Proposed Minor Relaxation of Building Height Restriction for Permitted Industrial Use cum Public Vehicle Park
Fanling Sheung Shui Town Lot 245, On Kui Street, Fanling
(Section 16 Planning Application No. A/FSS/306)

- Further Information No. 1 -

Items	Comments	Responses
1	Comments from Fanling, Sheung Shui & Yuen Long East District Planning Office, Planning Department received on 22 July 2026 (Contact Person: Mr. CHENG Chi Chiu, David, Tel: 3168 4046)

26017HK - 1/F_02 (SP01)

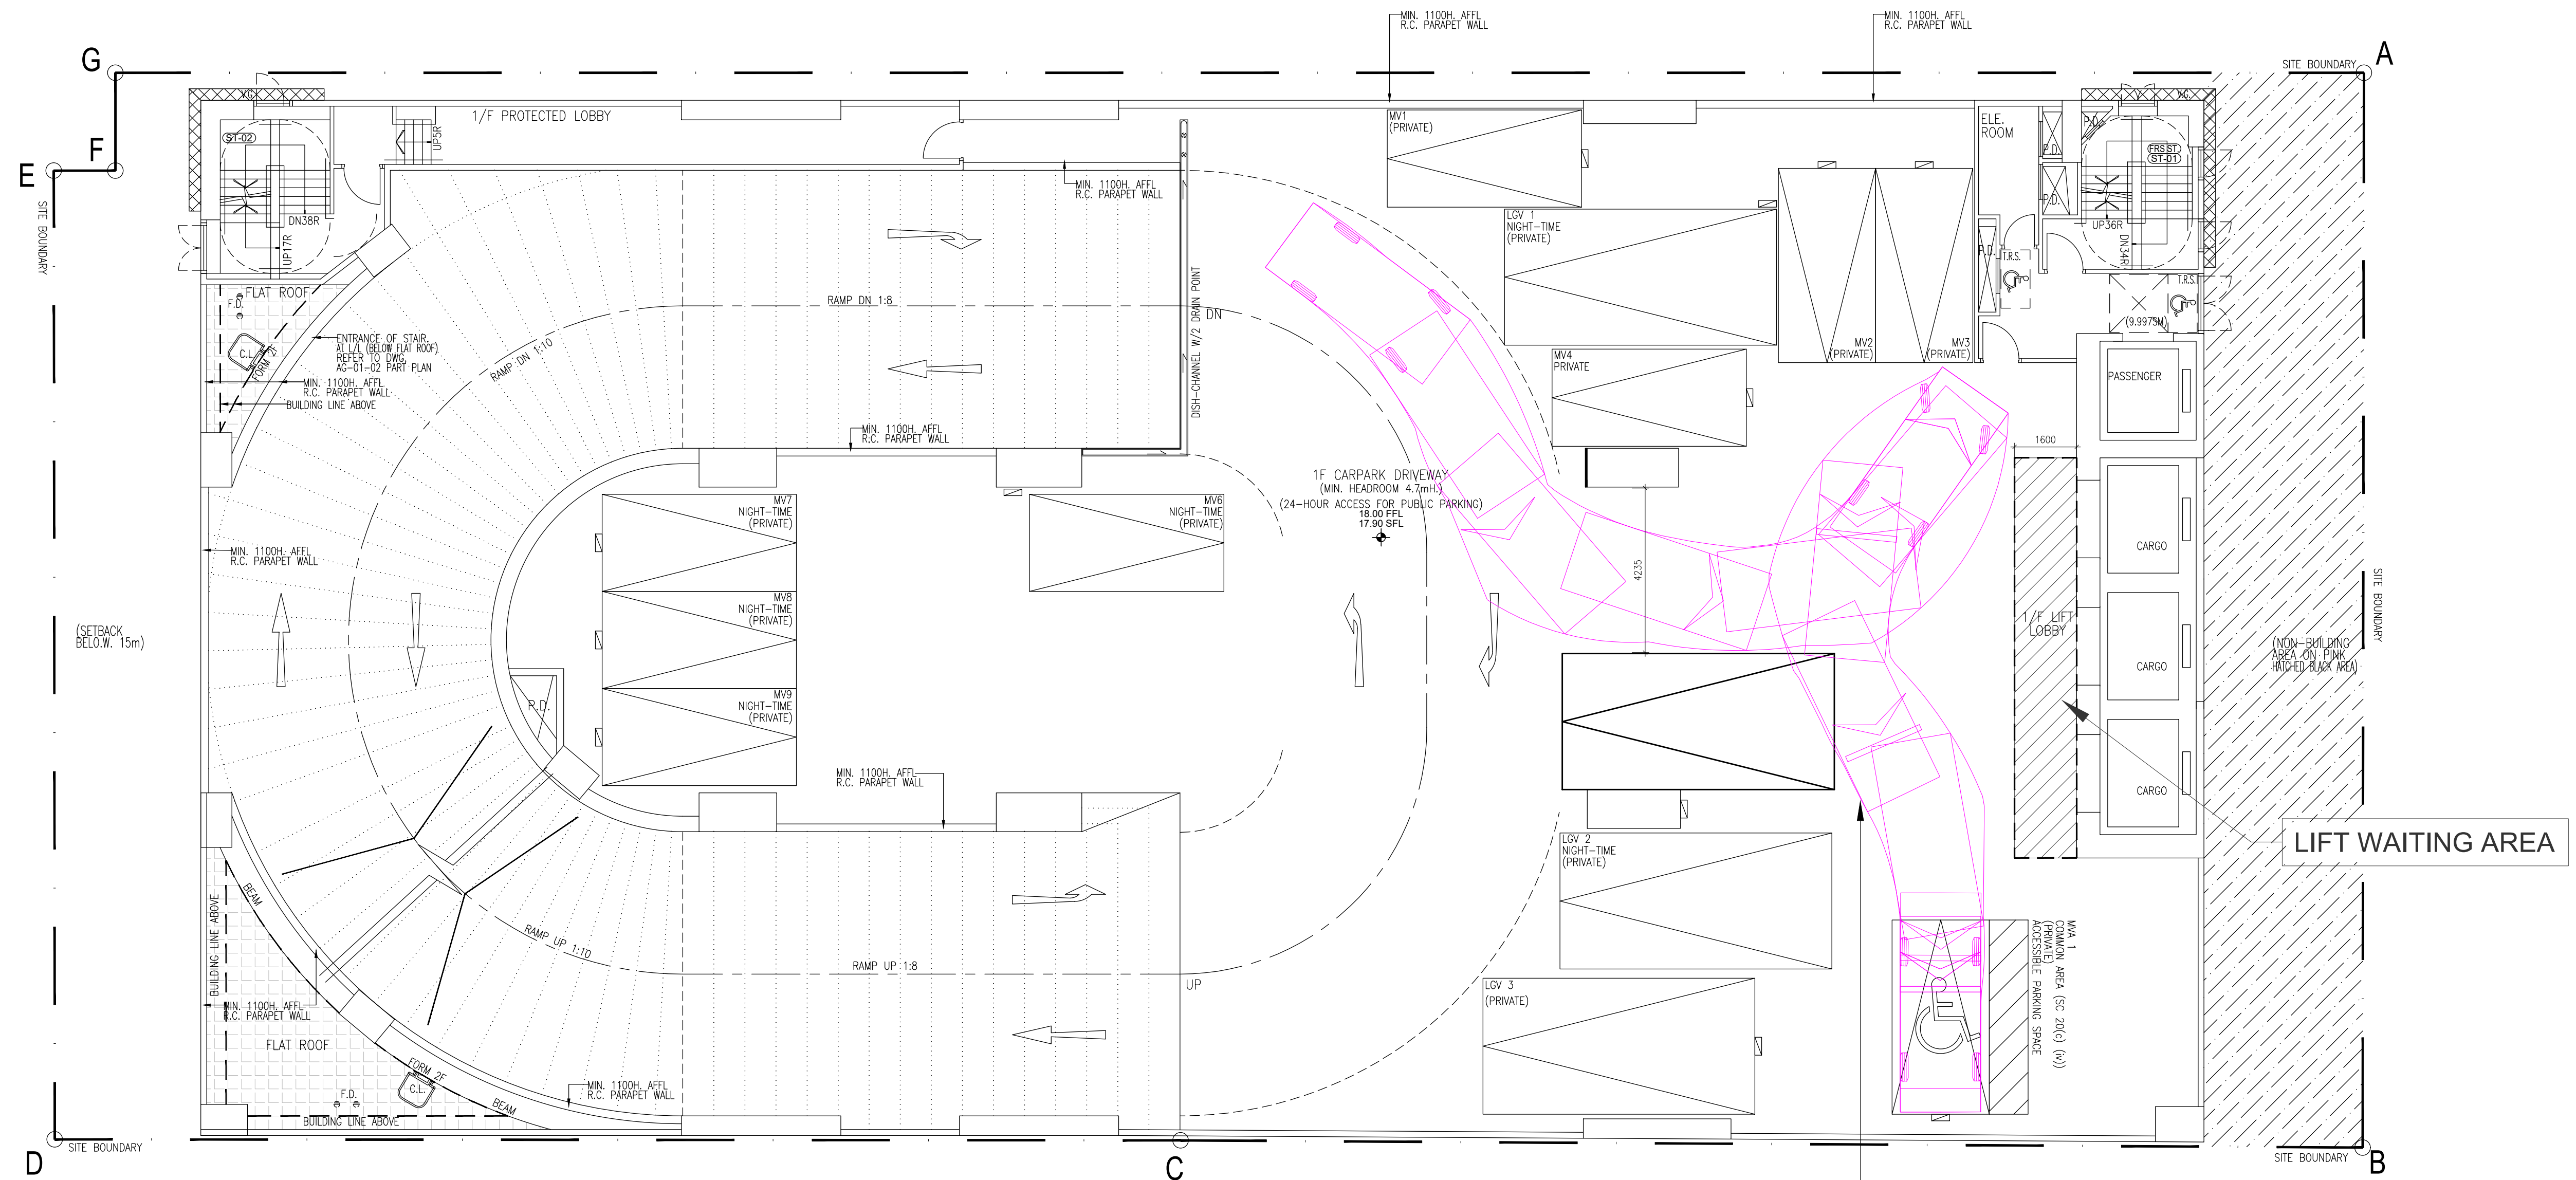
Items	Comments	Responses
		relocated to 5/F due to the full occupancy of parking spaces on 1/F to 4/F. The swept path analysis (Annex A refers) demonstrates that adding the LGV on 1/F will obstruct the private car manoeuvring into the accessible private car parking space. As a result, the f-t-f height of the PVP floor at 5/F is required to increase from 4m to 4.8m; iii) Under the approved GBP scheme, G/F serves both ancillary carpark and PVP uses, and 1/F to 4/F comprise four levels of PVP. The basement level accommodates the ancillary carpark only, which a significant amount of floor area under the vehicular ramp could be used for parking. Owing to the reduced coverage applicable to aboveground levels, larger vehicular ramp and manoeuvring space for PVP (MGVs), and the loss of the aforementioned parking space under the vehicular ramp, the floor area for ancillary carpark on 1/F of the Propose Scheme is about 270m² less than the basement level, which is insufficient to accommodate all the ancillary parking space at the basement level. Consequently, additional spaces are required on G/F for ancillary parking. As the provision of PVP spaces on other floors has already been optimised in the approved GBP scheme, the loss of parking spaces arising from the expanded ancillary car park can only be compensated through the provision of additional PVP floor area beyond the existing four PVP levels on 2/F to 5/F. At the same time, the approved GBP scheme has seven industrial floors from 5/F to 12/F. Of these, the three storeys under 47m in height adopt a site coverage of 77%, while the other four storeys above 47m are subject to a maximum site coverage of 65%. Such site coverage arrangement was formulated with reference to PNAP APP-132 in order to maximise the development footprint. However, under the proposed scheme, the introduction of the aboveground carpark shifts the industrial floors upward. As a result, only one industrial floor can retain the larger site coverage of 77%, while all remaining industrial floors are restricted to a maximum site coverage of 65%. Accordingly, the permitted

THE MANOEUVRING/PARKING FOR ACCESSIBLE PARKING SPACE
WILL BE OBSTRUCTED BY THE ADDITIONAL LGV SPACE

Figure 3.1 Indicative Section of the Approved GBP Scheme

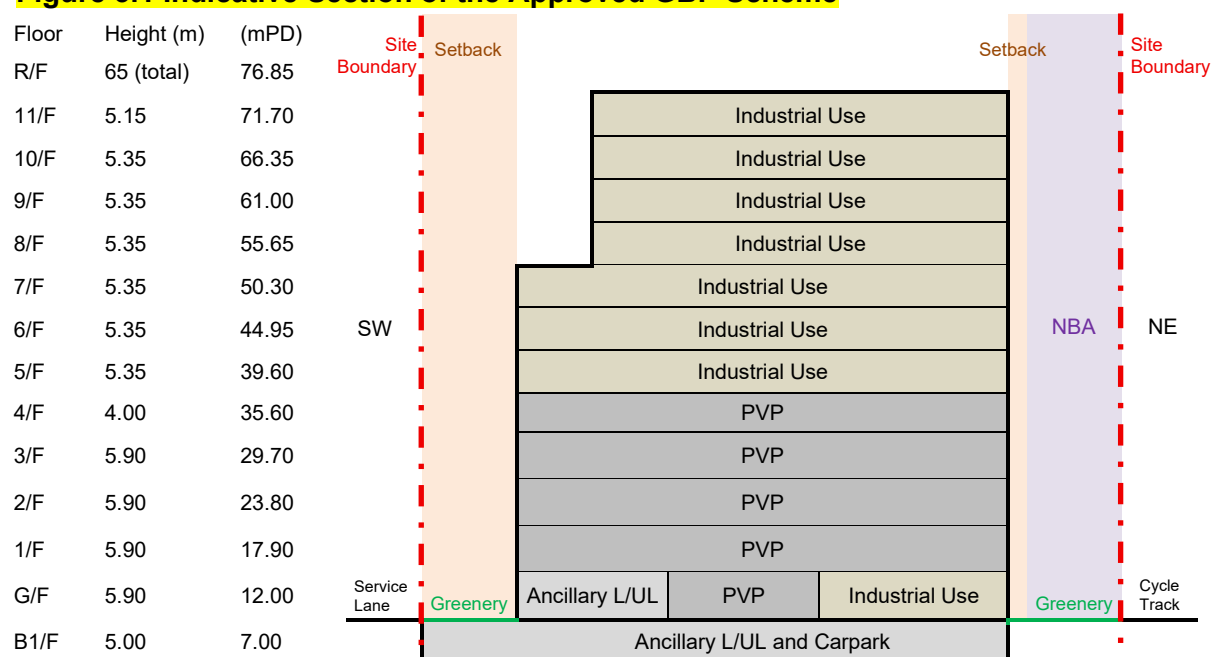
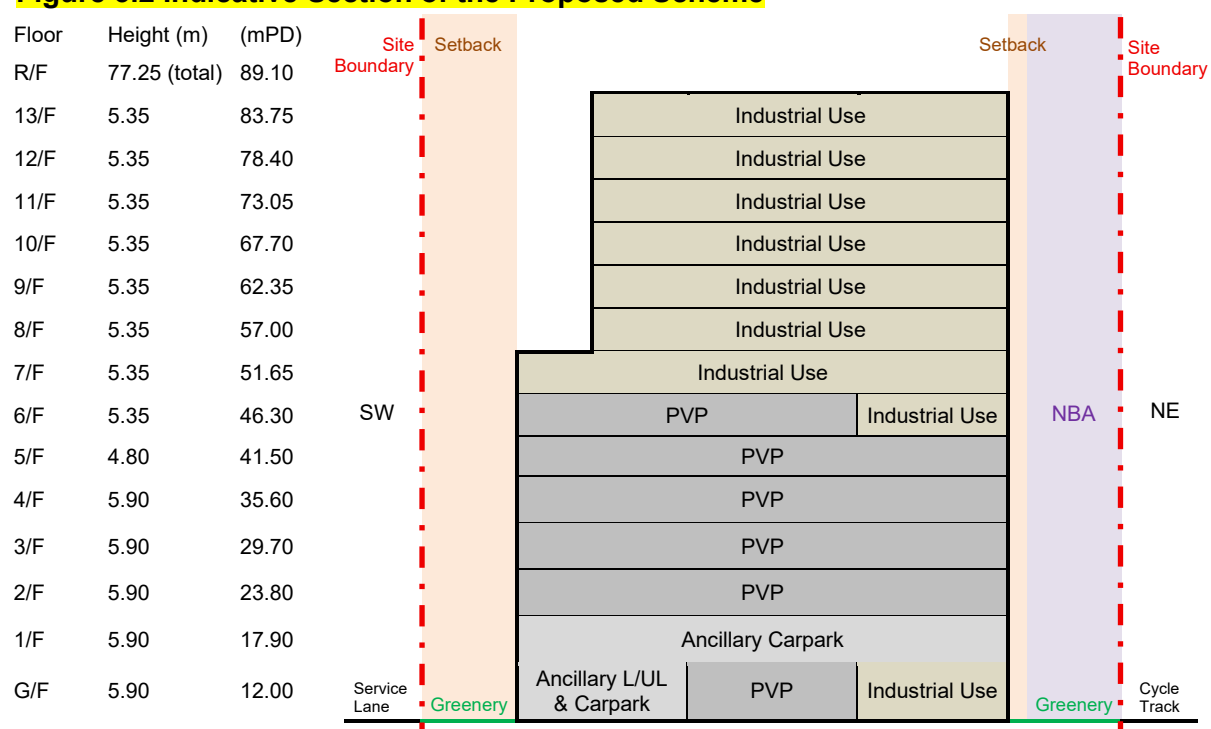
1.3	Table 3.1: It appears that the information for remarks (1) and (2) is missing. Please clarify;	Table 3.1 of the SPS has been updated.
1.4	Figures 3.1 and 3.2: According to p.8 of the Application Form and Schematic Architectural Drawings, industrial use will be provided on the G/F, whereas it is not shown in Figures 3.1 and 3.2. Please clarify;	Figures 3.1 and 3.2 of the SPS have been updated.

1.5	Figures 3.1 and 3.2: Please indicate the cycle track and service lane in Figures 3.1 and 3.2;	Figures 3.1 and 3.2 of the SPS have been updated.
1.6	Figure 3.1: According to paragraph 3.2.2 of the planning statement and the basement floor plan enclosed in the Tree Preservation and Removal Proposal, the basement floor under the approved GBP Scheme almost fully occupied the site, except for the area designated as non-building area (NBA). However, according to Figure 3.1, it appears that the NBA is still occupied by ancillary L/UL and carpark areas. Please clarify;	Figure 3.1 of the SPS has been revised.

FIGURE 3.1

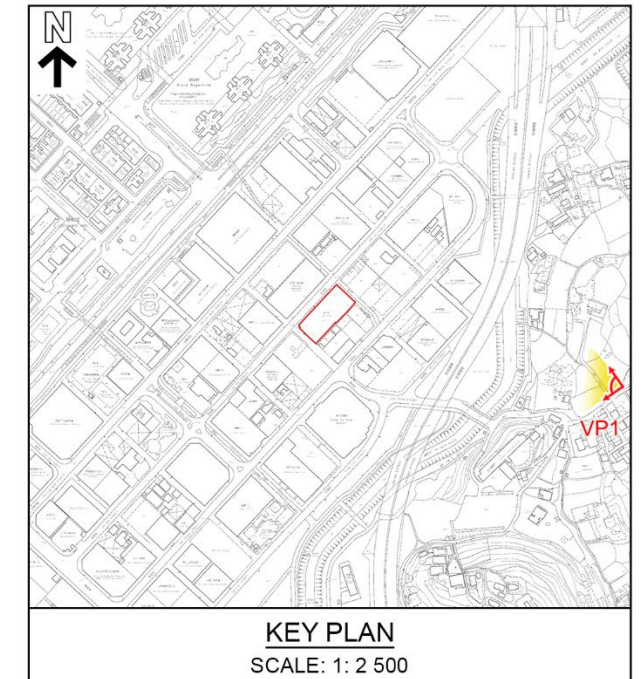
2.5	Figures 3.1 to 3.4 – blank façade treatment of the proposed development should be avoided.	Figures 3.1 to 3.4 of the VA have been revised.

FIGURE 3.2

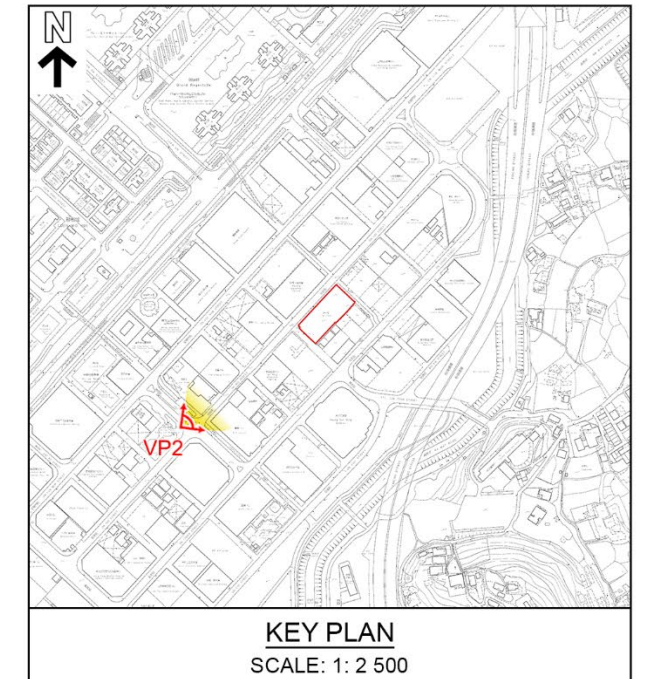
2.1	VP2 – given that the sensitivity of public viewers from this VP is high and part of the sky view will lose due to the proposed minor relaxation of building height restriction, the overall visual impact of the proposed development from this VP should be “moderate”;	The overall visual impact of the proposed development from VP2 has been revised to “moderate” in the Visual Appraisal (VA) (Annex C refers).

FIGURE 3.3

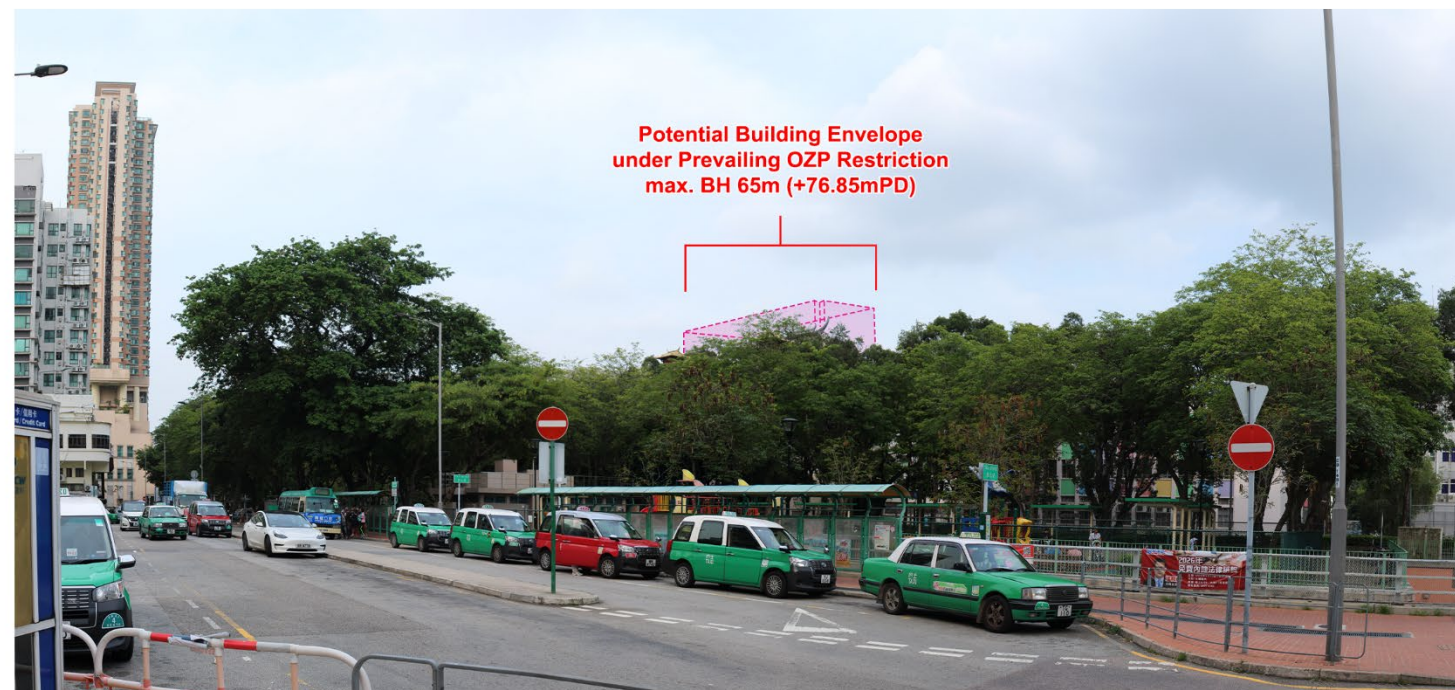
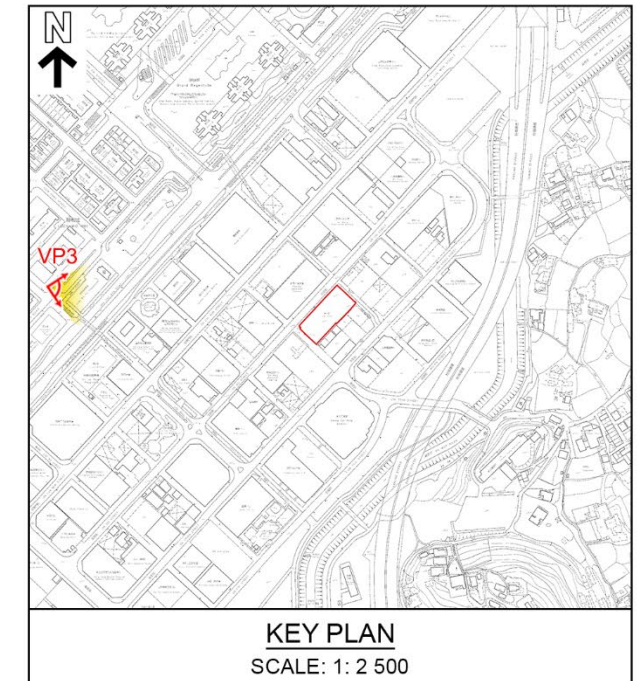
2.2	VP3 – the sensitivity of public viewers from this VP should be “medium”;	The sensitivity of public viewers from VP3 has been revised to “medium” in the VA.

2.3	Section 4 Conclusion should be suitably updated in view of the above comments;	Section 4 of the VA has been updated accordingly.
2.4	para. 3.4.1 – the sentence should read “High-rise residential developments can be seen in the far right <u>left</u> distance; and	Para. 3.4.1 of the VA has been revised.
